Seneca Valley High School, Mandatory Referral, MR2016010

Item 7- Part B. Mandatory Referral (MR2016):

Staff Recommendation: Approval to transmit comments to Montgomery County Public Schools

Staff recommends **approval** to transmit the following comments to the Montgomery County Public Schools:

OVERALL MANDATORY REFERRAL SITE PLAN

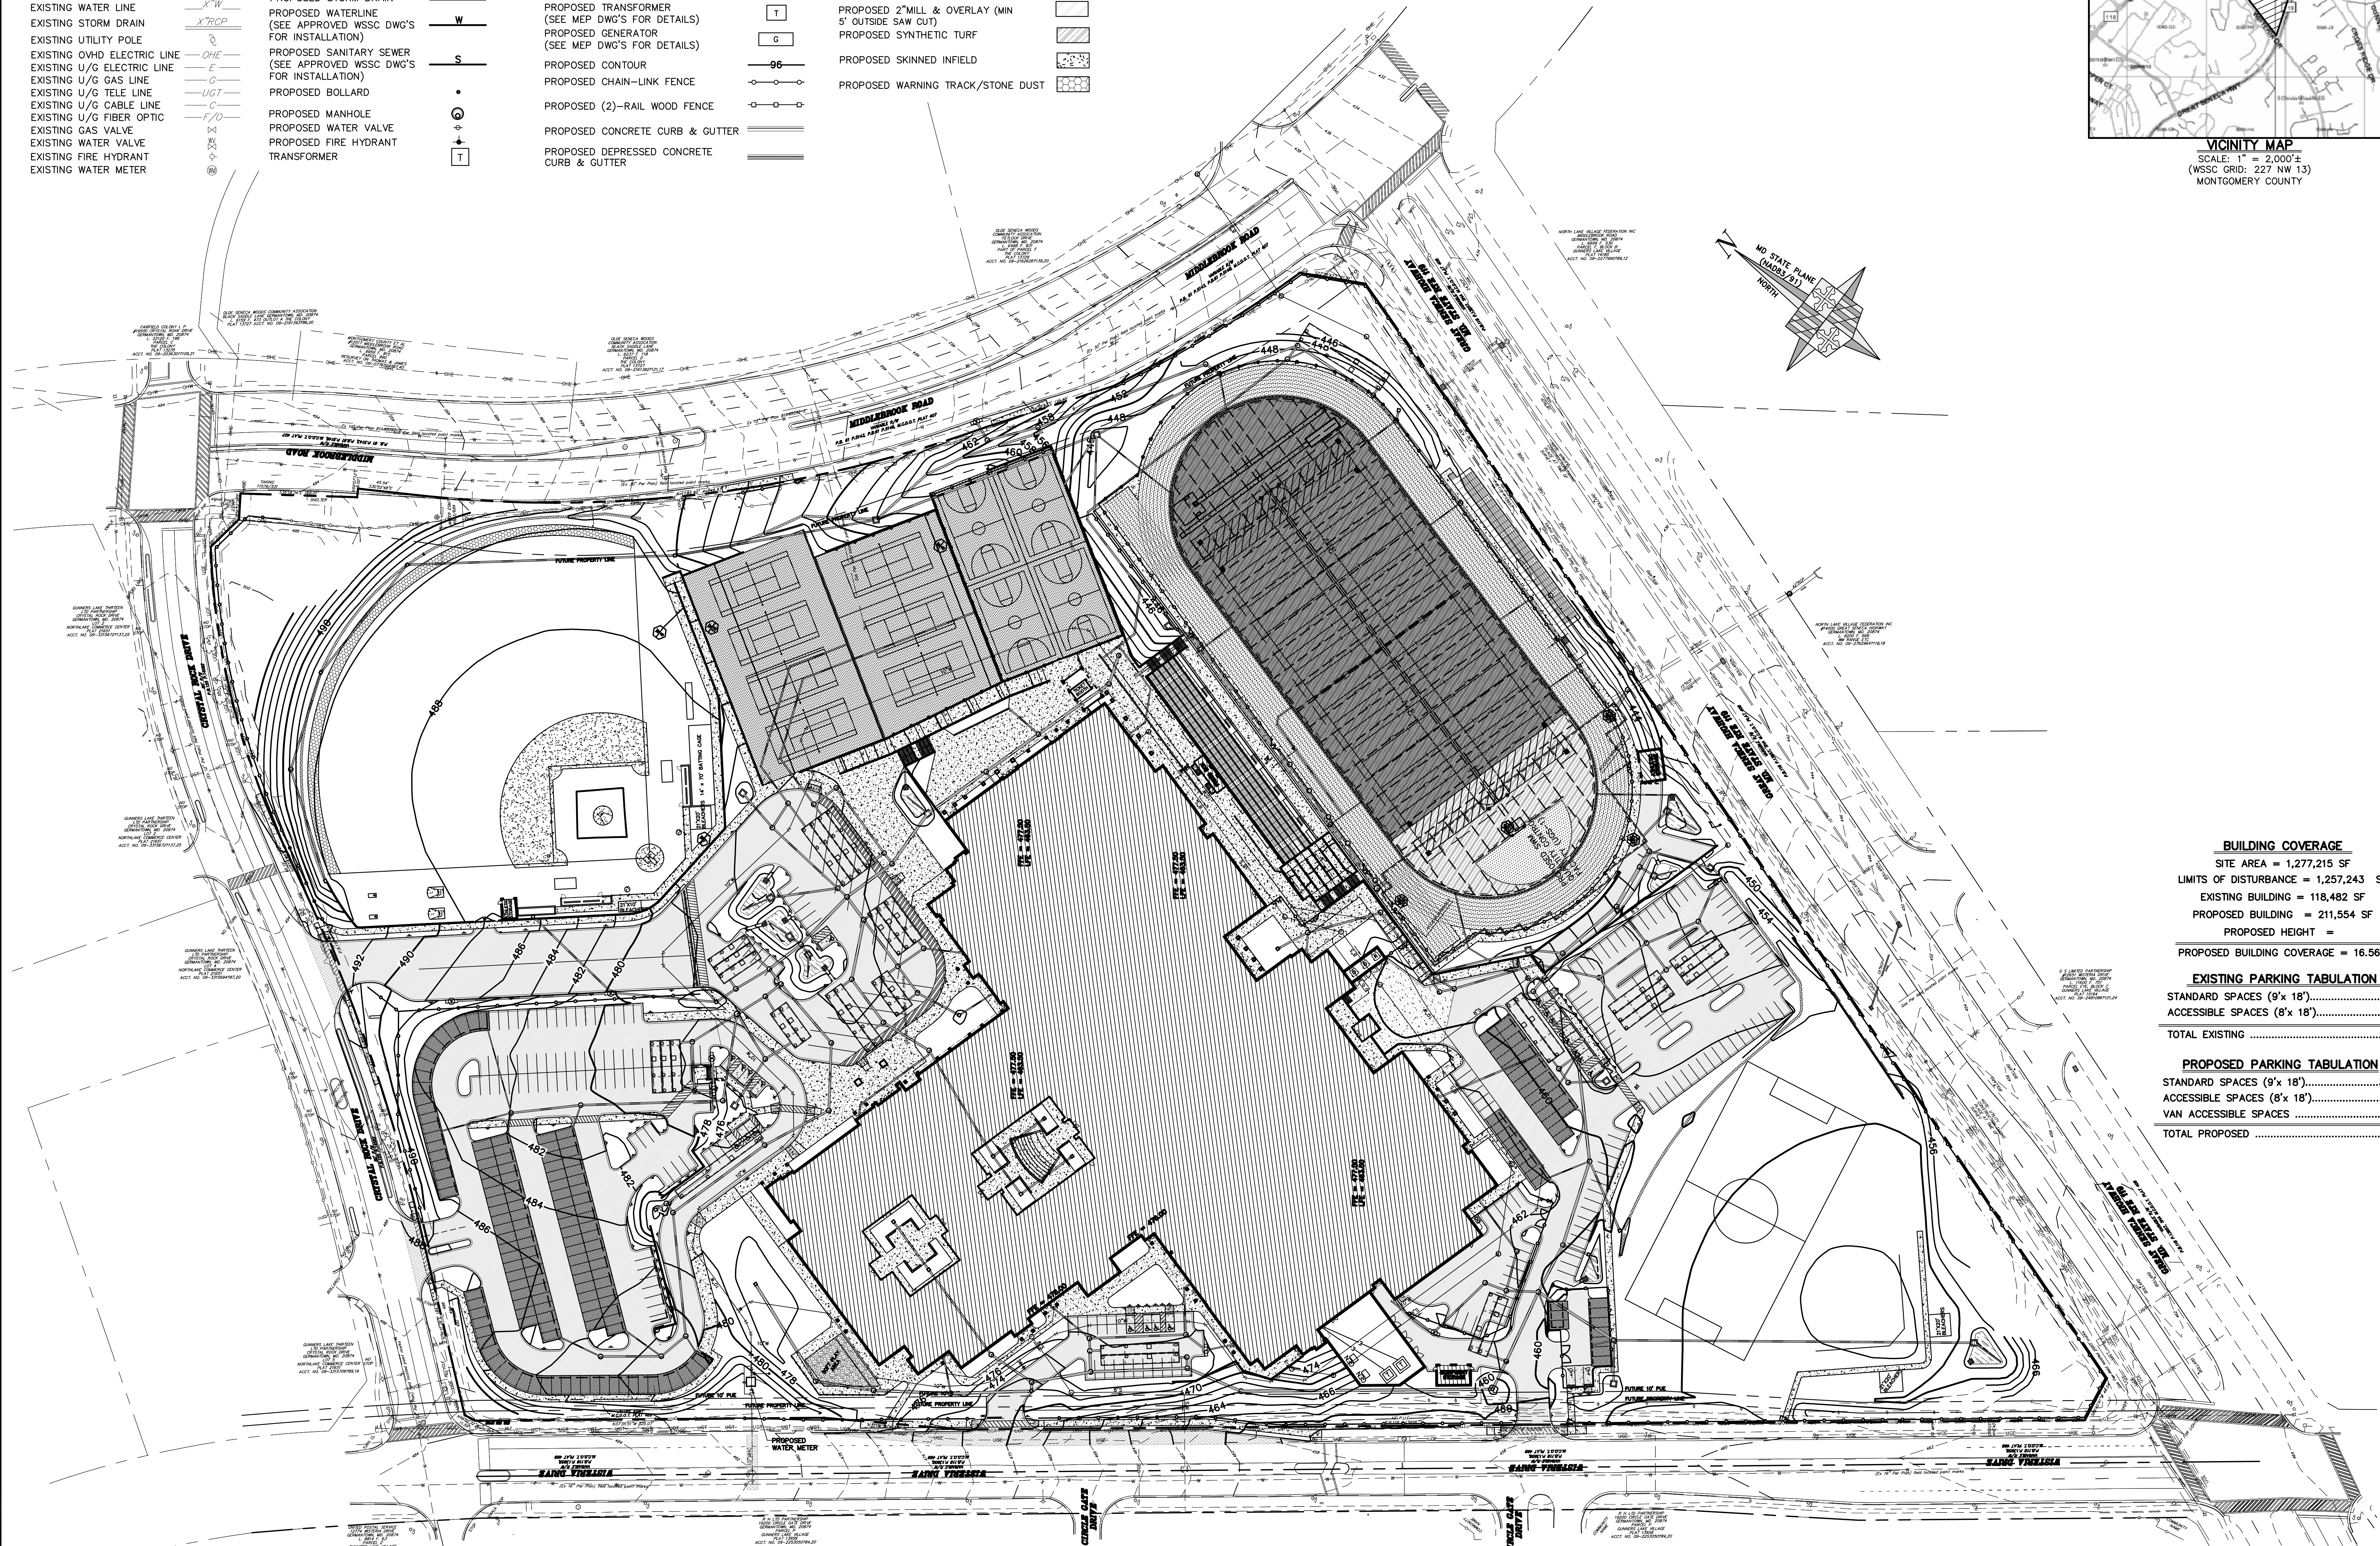
1. Ensure adequate sight distance and clear visibility of exiting vehicles from the proposed school site.
2. Ensure that the on-site parent drop-off and pick-up loops do not queue vehicles onto the adjacent streets by implementing a traffic operations program that accounts for all modes of access and large events operations.

3. Dedicate and show on the record plat dedication for the master-planned 150-foot-wide Middlebrook Road M-85 from the opposite right-of-way line (varies) along the subject property frontage. The amount of dedication will vary along the property line due to prior dedications or platting. Buildings must not be constructed in the dedicated area.

4. Dedicate and show on the record plat dedication for the master-planned 100-foot-wide Wisteria Drive A-74 from the opposite right-of-way line (varies) along the subject property frontage. The amount of dedication will vary along the property line due to prior dedications or platting. Buildings must not be constructed in the dedicated area.

5. Construct the master-planned shared use path along the subject property frontage of Crystal Rock Drive for the planned dual bikeway DB-34.
6. For safe off-site pedestrian circulation, provide an analysis of pedestrian crossing times at each of the studied signalized intersections (including those adjacent to, and those not adjacent to the school site) to the Montgomery County Department of Transportation (MCDOT) prior to occupancy of the new school.

7. If bicycle use is determined by the school principal to be an appropriate access means for students, plans for the locations of additional bicycle parking beyond that which is proposed will be needed and should be coordinated with M-NCPPC and DOT.

8. Provide an adequate number of vehicular parking spaces on the site.
